CITY OF BETHLEHEM

BUREAU OF PLANNING AND ZONING

March 3, 2022

RE: (21-008 LD&S – 21060017) – 2285 & 2425 Schoenersville Road, Land Development & Subdivision Plan (Phase 3) – Zoned CS, Plans dated June 4, 2021 and revised January 27, 2022.

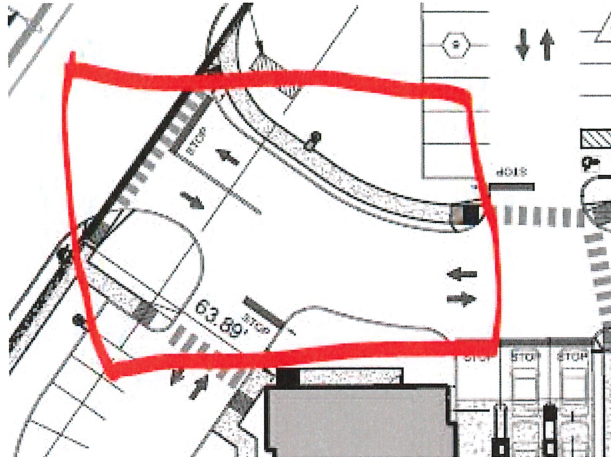
1. Indicate if the driveway across from Statten Ave. can be realigned to line up with the interior drive-thru aisle for the café. It is assumed most vehicles coming in this entrance are going to the drive-thru and a straight movement seems to make more sense.
2. The traffic submission to PennDOT will be reviewed with the City's Traffic Consultant and his comments will be submitted under separate cover once PennDOT responds.
3. In coordination with LANTA, the existing bus shelter and pad on Westgate Drive shall be removed with the sidewalk installation. A new bus location is being planned on site.

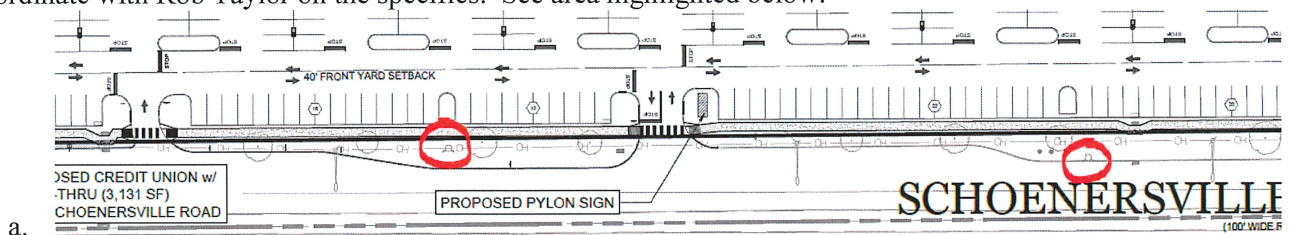
1. A fire hydrant must be added along the driveway next to the proposed credit union. Coordinate with Rob Taylor on the specific location and tie-in options. See area highlighted below:
